Project Number: 21-11-134

Re: Stowell Awning – 4 Bay Outdoor Structure
Seattle, WA

ESR: Updated 6' Wide 4 Bay Structure

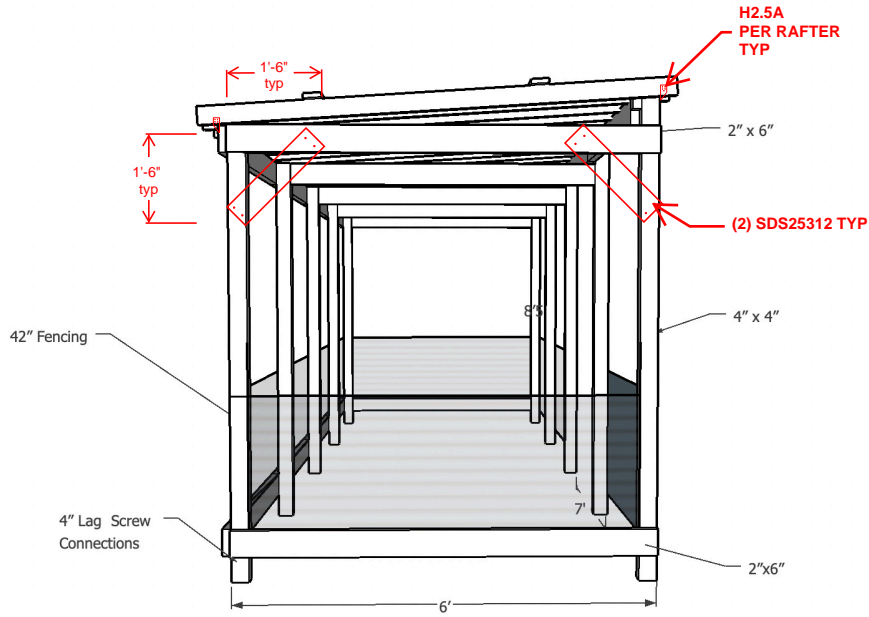
INSTALL (N) 2X6 KNEE BRACES AS SHOWN W/ (2) SDS25312 SCREWS @ EA END, TYP

MIN 325 LBF BALLAST WEIGHT @ EA POST, TYP.
